CITY OF FORT LAUDERDALE

# DEVELOPMENT REVIEW COMMITTEE

## CASE COMMENT REPORT

<b>CASE</b>	UDP-S24046
<b>PROJECT NAME</b>	Carter Plaza
<b>APPLICATION TYPE</b>	Site Plan Level II
<b>APPROVAL LEVEL</b>	DRC Approval
<b>REQUEST</b>	3,930 Square-Foot Office
<b>APPLICANT</b>	Jerry and Ella Carter
<b>AGENT</b>	Donald Senatore (Architect)
<b>PROPERTY ADDRESS</b>	2405 NW 19 <sup>th</sup> Street
<b>ABBREVIATED LEGAL DESCRIPTION</b>	North West Lauderdale 25-25 B Lot 50,51 Blk 2
<b>ZONING DISTRICT</b>	B-3 (County Zoning)
<b>LAND USE</b>	Commercial
<b>COMMISSION DISTRICT</b>	3 - Pamela Beasley-Pittman
<b>NEIGHBORHOOD ASSOCIATION</b>	Rock Island Community Dev.
<b>SUBMITTAL</b>	June 21, 2024
<b>COMPLETENESS ISSUED</b>	December 19, 2024
<b>EXPIRATION</b>	April 18, 2025 (120 Days)
<b>WAIVER</b>	Not Requested
<b>CASE PLANNER</b>	Nancy Garcia Urban Planner II

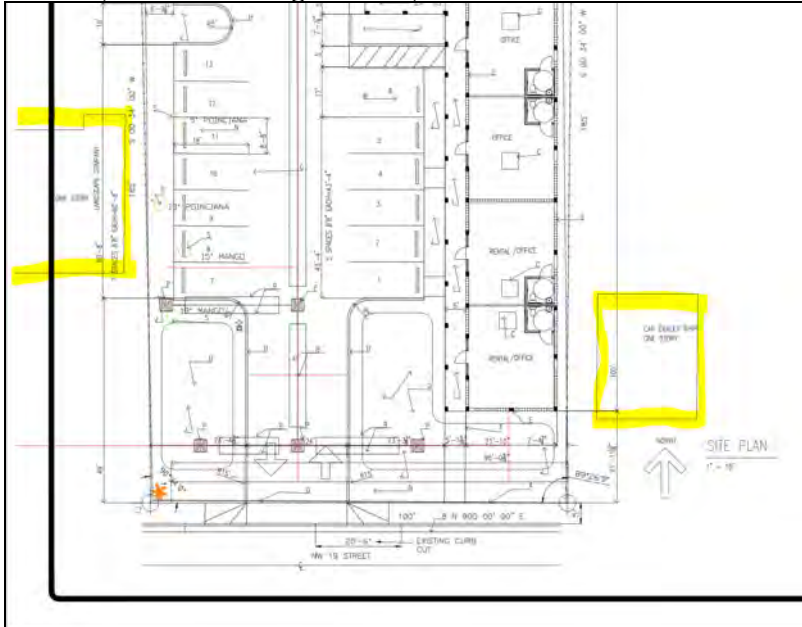
- d. Indicate all adjacent property boundaries, building footprints, indicating their uses and heights, and dimension approximate setbacks. Sheet A-2 appears to show the adjacent uses, however the drawings should be shifted or centered on the page so that the buildings are not cut-off (reference image below).

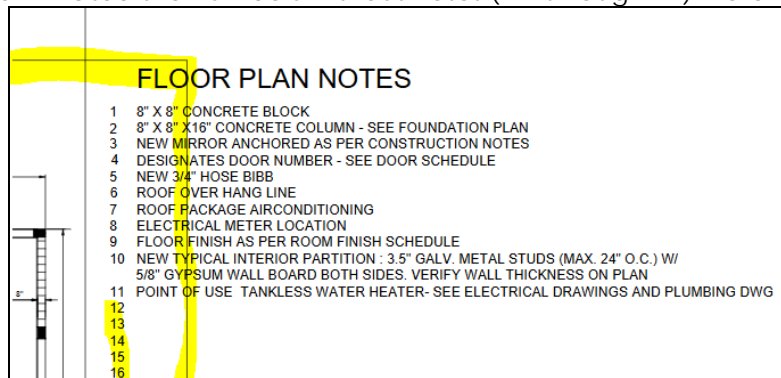
- i. Sheet A-5 and A-6 should show the floor plan as a singular building instead of split into two views.
  - j. Revise the floor plan notes on Sheet A-5 so that the drawing does not overlap the text. Also eliminated the numbers without notes (12 through 27). Reference image below):
